RECALL 23V227 / 2023-193 REMEDY INSTRUCTIONS

CERTAIN – 2023 DELLA TERRA - DET240RLLE & DET255BHLE CERTAIN – 2023 SILVER LAKE - SKT24RLLE & SKT26BHLE

RECALL 23V227 / 2023-193 FOREST RIVER UNDERMOUNT DRAWBAR REMEDY

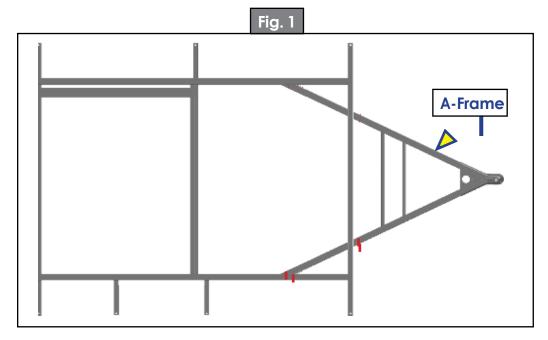
- 1. Properly support the frame according to manufacturer's guidelines.
- 2. Cut the A-frame from underneath the main frame rail and the front crossmember (Fig. 1).

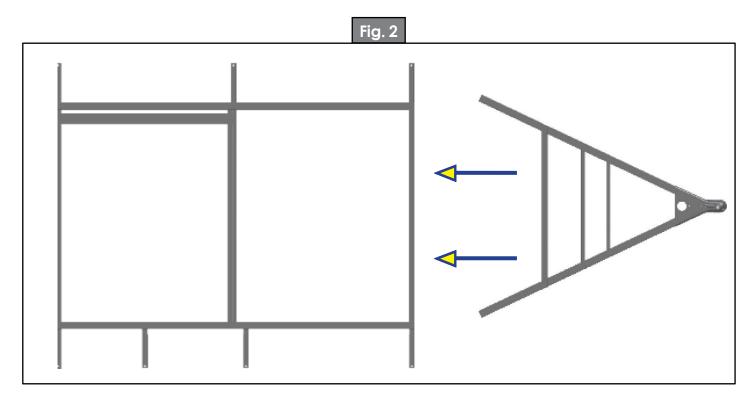
3. Position replacement A-frame (Fig. 2).

NoTe: Ensure that the A-frame is level or horizontal to the main frame. This will ensure that when it is welded in, the replacement A-frame is not sloped up or down.

- A Measure from the outer end of the A-frame tube to the header on both sides. This measurement should be 27 3/4" (Fig. 3). This will align the coupler to the center line of the frame (Fig. 3).
- **B.** Measure from the center of the coupler to the header. This measurement should be 48" (Fig. 3).

4. Weld A-frame underneath main frame rail and front crossmember (Fig. 3).
